<p><b>SUNDRY NOTICES AND REPORTS ON WELLS</b> (DO NOT USE THIS FORM FOR PROPOSALS TO DRILL OR TO DEEPEN OR PLUG BACK TO A DIFFERENT RESERVOIR. USE "APPLICATION FOR PERMIT" (FORM C-101) FOR SUCH PROPOSALS.)</p>		WELL API NO. 30-005-00888

At the request of the BLM, Great Western Drilling Company asks, respectfully, for approval to plug and abandon the Rock Queen Unit #32 well.

**Rock Queen #32 P&A Procedure**

**Rock Queen Unit 32  
30-005-00888  
Great Western  
January 05, 2026  
Conditions of Approval**

## ROCK QUEEN UNIT #32 - PROPOSED as of 01/20/2026

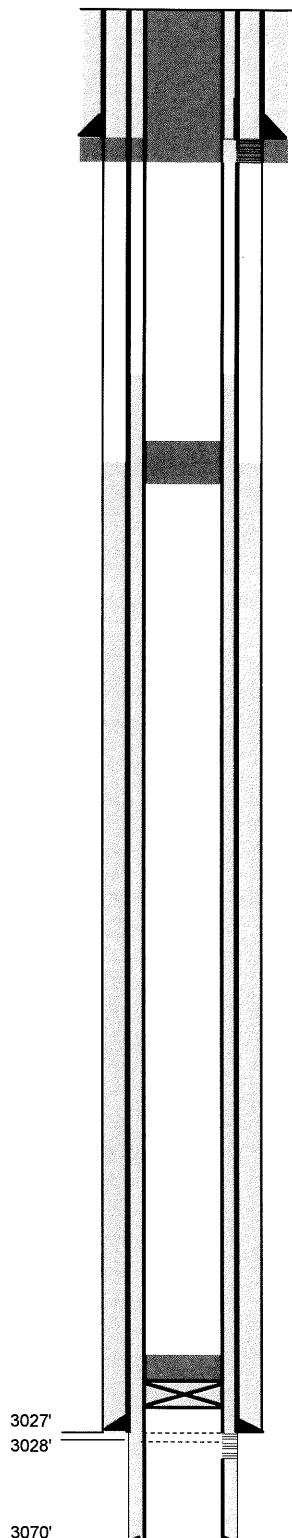
1. Operator shall tag CIBP at 2,962' with cement. Please be sure there is a minimum of 25 sx of Class C cement on top of the CIBP. If cement is added please WOC and TAG.
2. Operator shall place a solid class C cement plug from 2,324'-2,098' to isolate the top of the Yates and the bottom of the Salt. WOC and TAG.
3. Operator shall place a solid class C cement plug from 1,555'-1,393' to seal the top of Salt and Rustler. WOC and TAG.
4. Operator shall perf at 377' and squeeze cement class C cement to surface to seal the 8-5/8" casing. WOC and TAG.
5. Dry hole marker must be below ground.
6. Surface reclamation will need to be completed once the well bore has been plugged. Please contact rflores@blm.gov for additional information.
7. See Attached for general plugging stipulations.
